**40GBASE-ER4**  
**proposed revision to receive**  
**power max spec**

11<sup>th</sup> June 2013

Jonathan King, Finisar

# Measurements

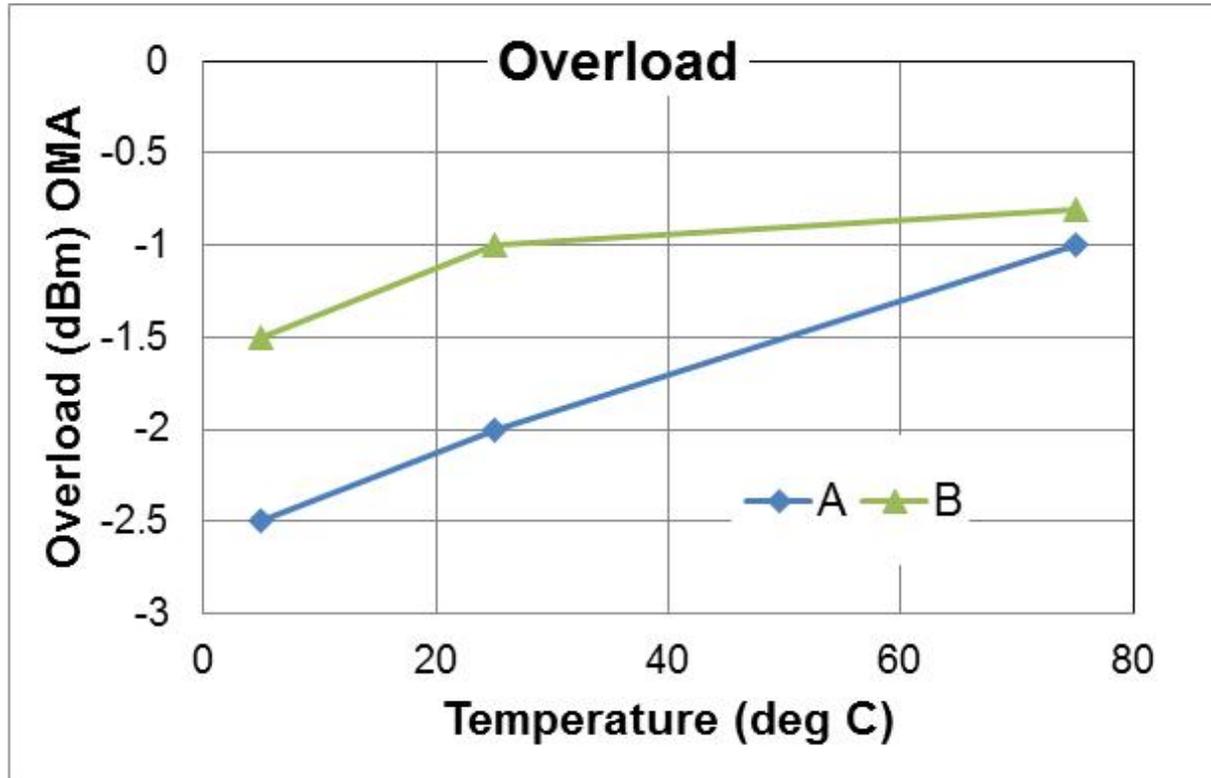
- Two 10Gb/s APD suppliers, same TIA, overload v. temperature
  - (max 2 mA 'OMA' photo-current input)
- Max input OMA, min APD gain combination, for BER= $10^{-12}$ 
  - neither meets an overload spec of -1 dBm OMA, both meet -4 dBm OMA spec with ~1.5 dB margin
